November 27, 2017

Motor Business Unit,
Electromechanical Control Business Division,
Automotive & Industrial Systems Company,
Panasonic Corporation

Software Version Upgrade Notice
for AC Servo Driver of MINAS A6BE series

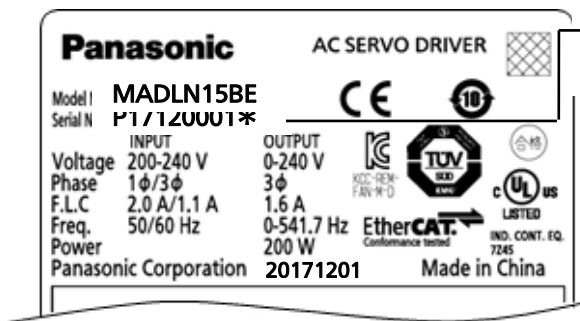
• Method of checking the year and month of manufacturing from the manufacturing code (serial number)

The manufacturing code (serial number) shown on the name plate located on the side of the product conforms to the following rule.

Manufacturing code (serial number)

Ex. **P17120001** *

T	T	T	E	Serial number *1	} Check the year and month of manufacturing.
1	7	1	2	Month of manufacturing	
0	0	0	0	Year of manufacturing (last 2 digits of calendar year)
